# Access Compliance Report

## Public Rights-of-Way

Intersection ID: 51439	Main Street: WOODLAND_WATCH_CT	Cross Street: LIPPARDS_HUNT_CT	Location: SE
ADA ID: 0CDFACC46079	Ramp Type: Perp	Initial Pass/Fail: Fail	Overall Compliance: No
Severity Score: 13.75			
Codes/Mitigation Info/Possible Solution		Field Measurements/Component Compliance

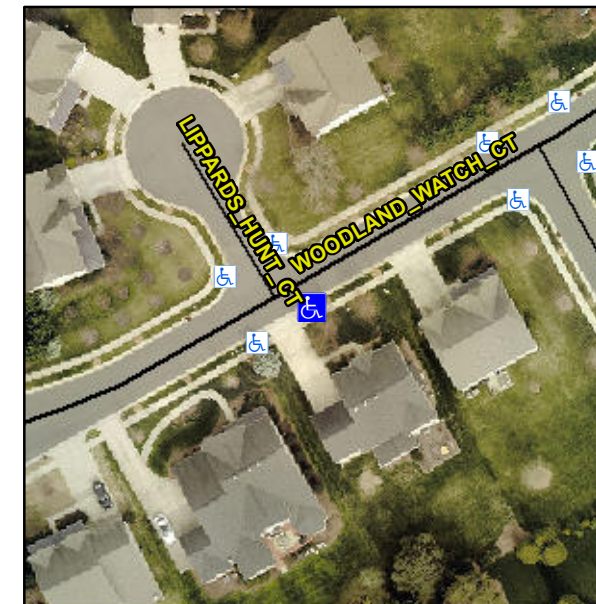
**Not Found, R304.2.2**

Compliance	Description	Data	Compliance	Description	Data
N/A	Ramp Length (in)	48.0	No	Ramp Slope (%)	10.3
Yes	Ramp Width (in)	48.0	Yes	Ramp XSlope (%)	4.0
N/A	Flare Type LT	N/A	N/A	Flare Type RT	N/A
N/A	Flare Slope LT (%)	N/A	N/A	Flare Slope RT (%)	N/A
N/A	Flare Traversable LT?	N/A	N/A	Flare Traversable RT?	N/A
N/A	Landing Length (in)	N/A	N/A	DWS Provided?	N/A
N/A	Landing Width (in)	N/A	N/A	DWS Contrast?	N/A
N/A	Landing Slope (%)	N/A	N/A	DWS Length (in)	N/A
N/A	Landing X Slope (%)	N/A	N/A	DWS Full Width?	N/A
N/A	Landing Curb? (Y/N)	N/A	N/A	DWS Offset (in)	N/A
N/A	Shared Landing?	N/A			
N/A	Gutter Ponding?	N/A	N/A	Gutter Slope (%)	N/A
N/A	Gutter Lip Ht (in)	N/A	N/A	Gutter X Slope (%)	N/A
N/A	Painted X Walk1?	No	N/A	Painted X Walk2?	N/A
	X Walk 1 Direction	To NW		X Walk 2 Direction	N/A
N/A	X Walk 1 Width (in)	N/A	N/A	X Walk 2 Width (in)	N/A
	X Walk 1 Slope (%)	0.2		X Walk 2 Slope (%)	N/A
	X Walk 1 X Slope (%)	4.4		X Walk 2 X Slope (%)	N/A

**Remove & Replace Entire Ramp.**
